CITY OF NEW YORK
 DEPARTMENT OF ENVIRONMENTAL PROTECTION
 BUREAU OF ENGINEERING DESIGN & CONSTRUCTION
 WM-30 WATERSHED IMPROVEMENTS
 RECONSTRUCTION OF
 CATSKILL WATERSHED DAMS AND ASSOCIATED FACILITIES

GILBOA DAM AND ASSOCIATED FACILITIES RECONSTRUCTION
 CONTRACT CAT-212B
 ARCHITECTURAL
 DAM RECONSTRUCTION
 DETAILS - SHEET 3 OF 5

90% SUBMITTAL
 DATE: AUGUST 2009
 SHEET NO: A19 OF
 DWG NO: A-SD-103

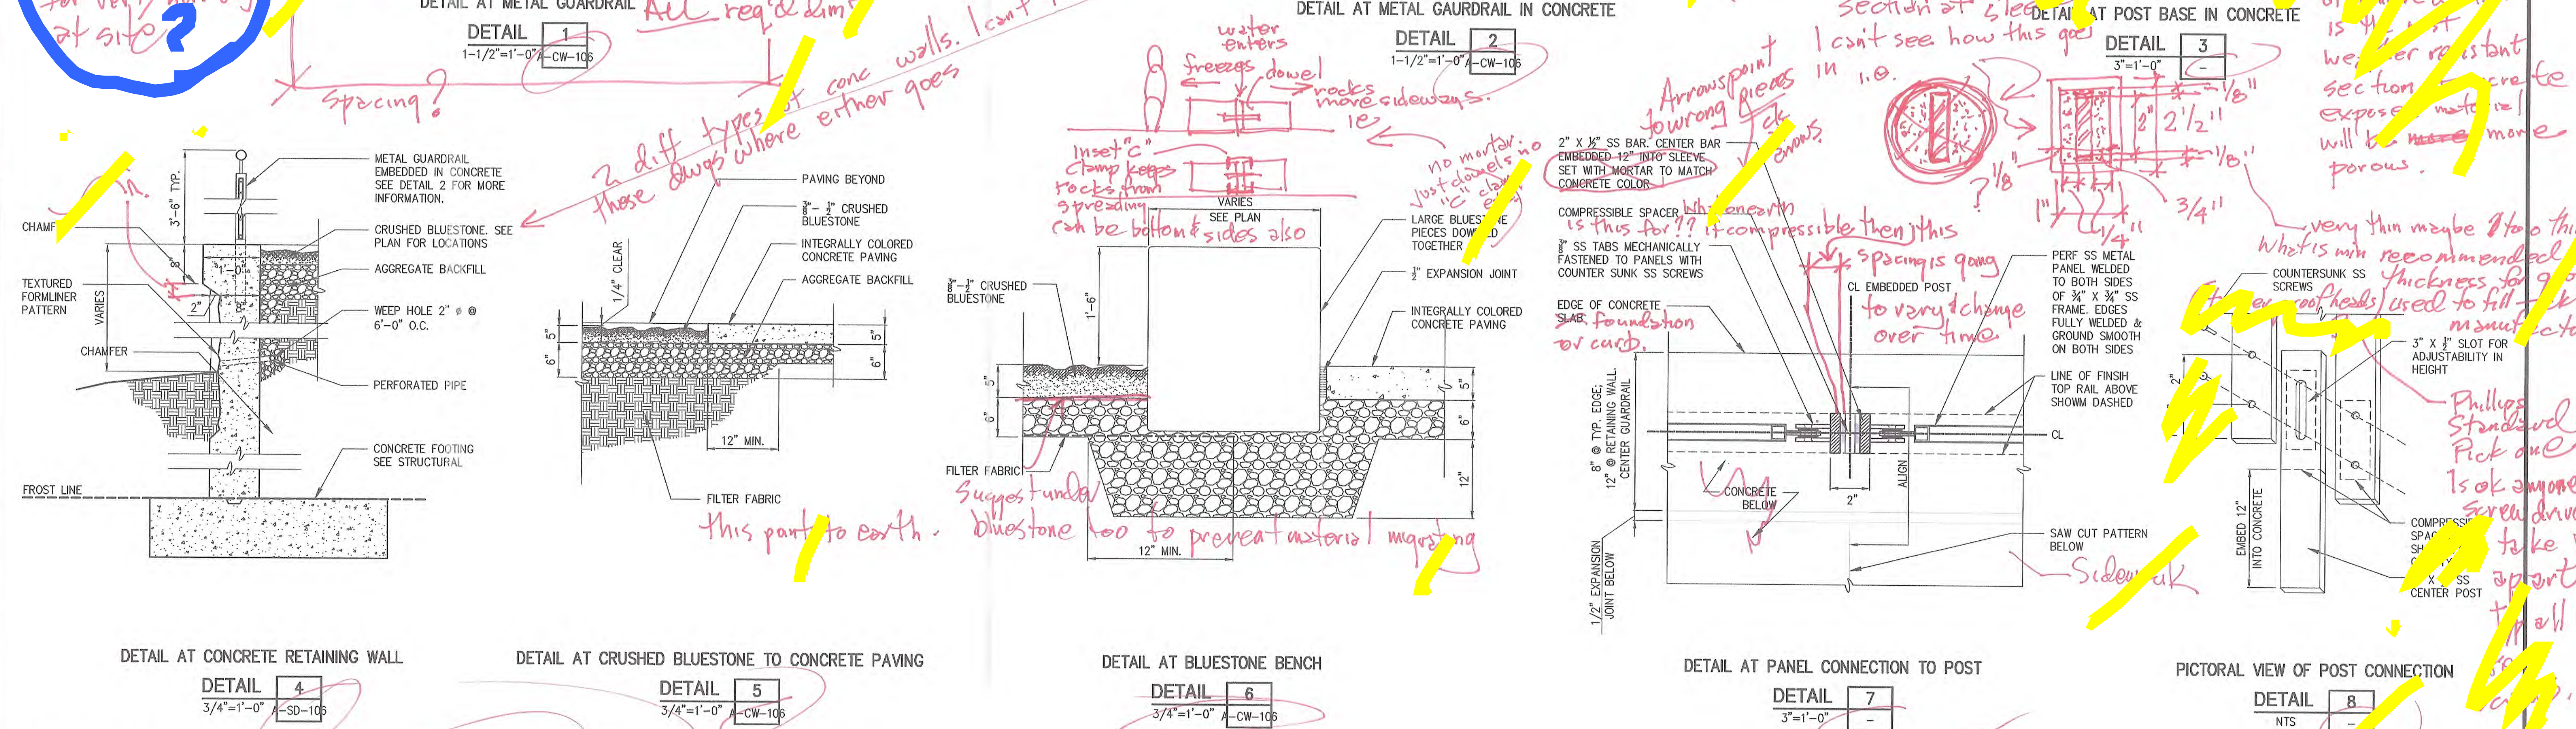
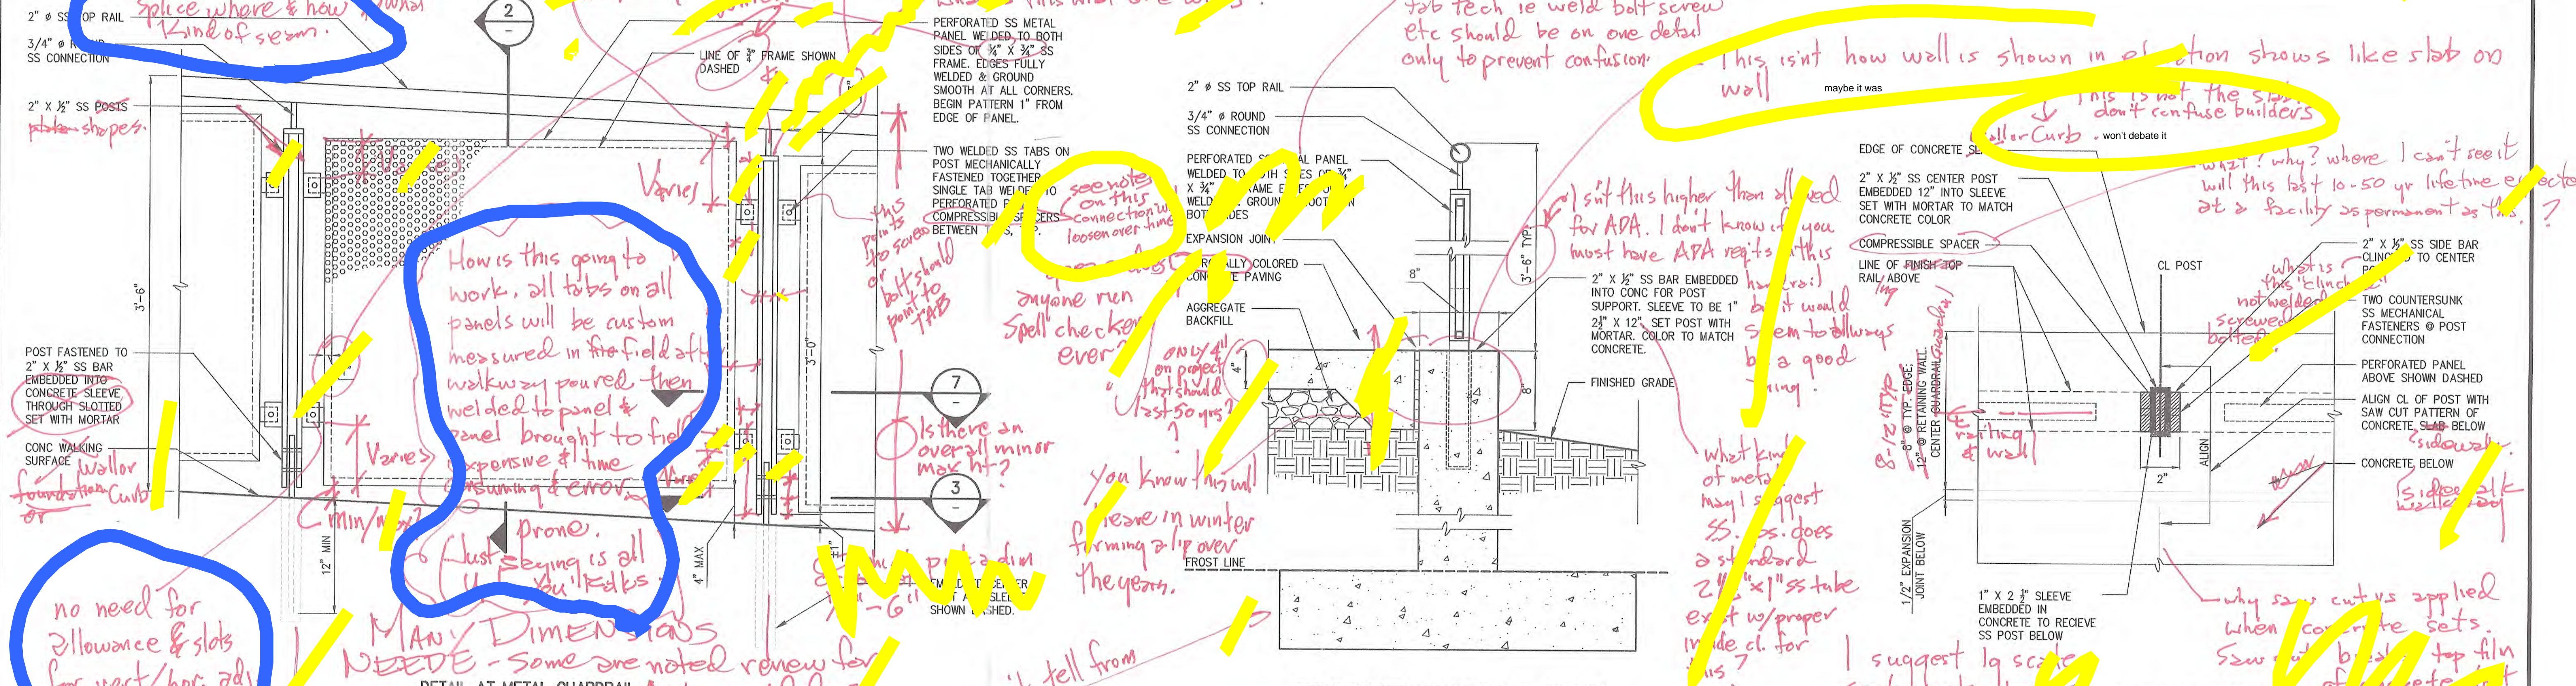
what this what are dimensions? what is this distance? maybe its not critical but it's not like this...
